Proposed Revision to Module-2 Charge Readout Ground Scheme

Brooke Russell
ArgonCube Engineering Meeting
November 4, 2022

Module-1 Anode Tile Grounding

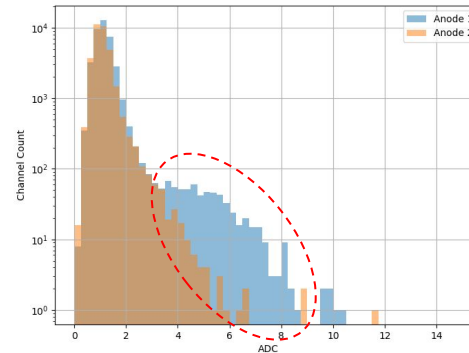
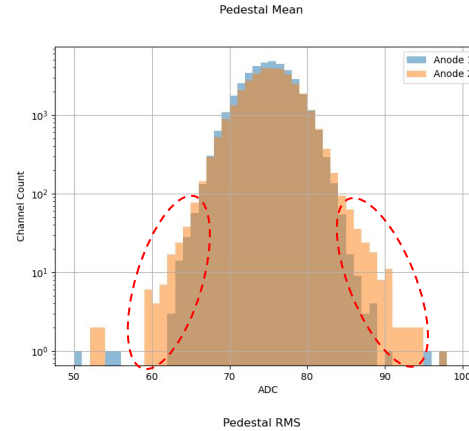
DC pedestal offset at tile-edge pixels for non-CWTT anode

x2-4 increase in noise for tile-edge pixels on edge opposite of light attachment (vertical centerline on anode) for CWTT anode

- Planned column-wise tile-tile ground cable
- Proposed ground cable connection

Ground cable attachment point for adjacent tile ground cable
